**TECHNICAL BULLETIN
No. 0119**

**PA Transmission
Case Dimensions**

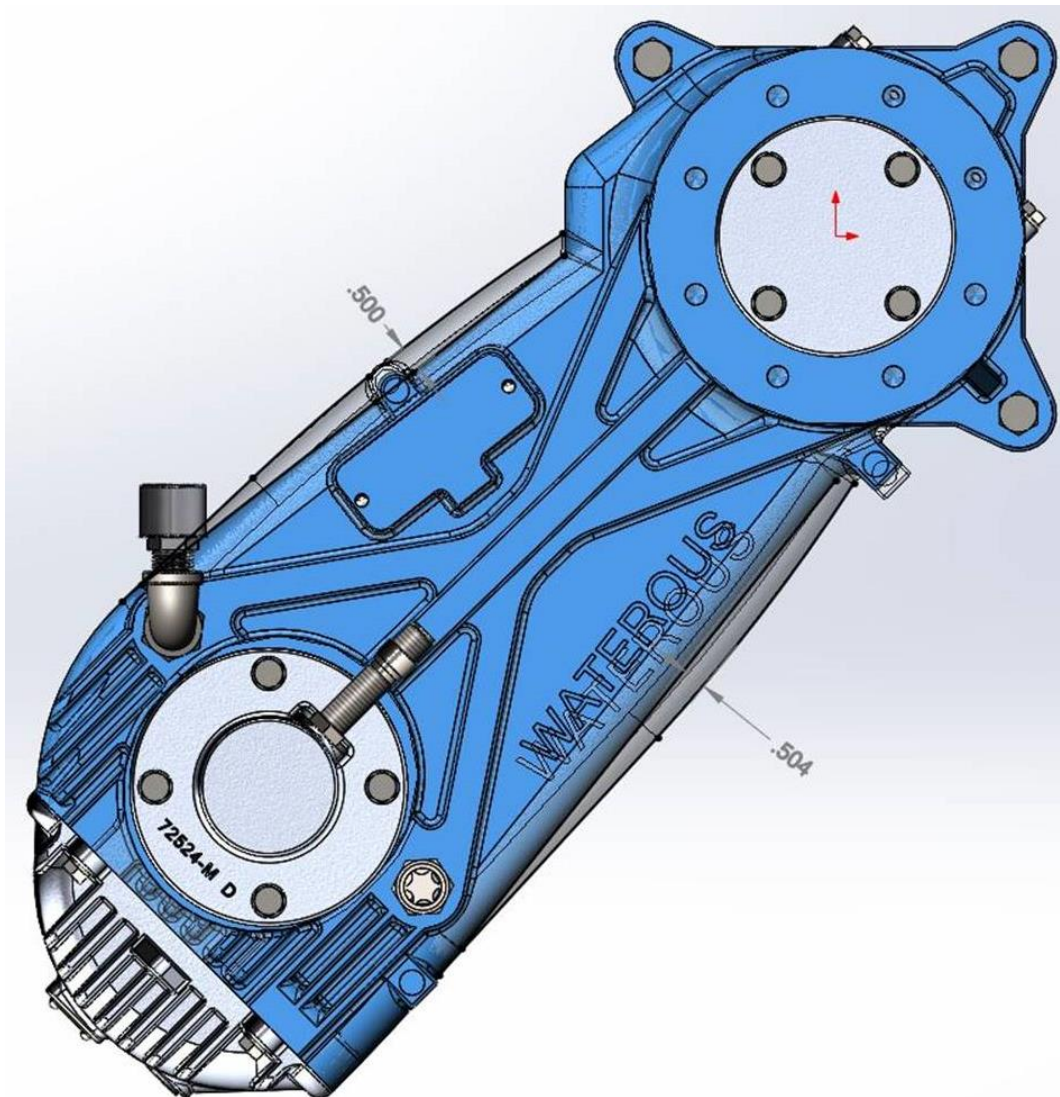
On orders shipped after October 3, 2016 the PA Transmission with 2.10 Ratio will have a new case dimension shown in the figure below. This dimensional change allows for more oil flow inside the case for better chain lubrication.

At a later date, PA Transmissions with 1.70 and 1.90 Ratios will change to the case dimensions as shown in the figure below.

The figure below shows the dimensional differences between the current PA Case and the updated PA Case.
